## **PLAN REVIEW SHEET**

2015-038

Meritage Homes of the Carolinas

Waiting Pad Detail

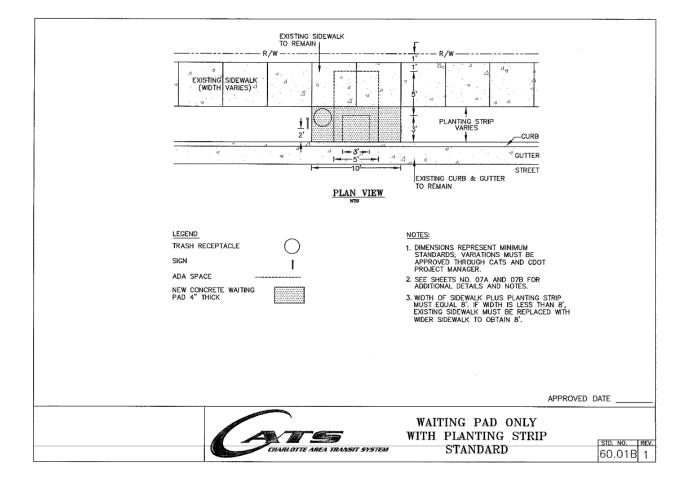
The Petitioner is requested to provide and construct a concrete pad for the existing bus stop on Providence Road. Below is an image of the standard detail (60.01B) for the requested concrete pad. The site plan may either show the conceptual location of the improved bus stop on Providence Road, or alternatively, include a development note to locate the bus stop pad during the urban review process.
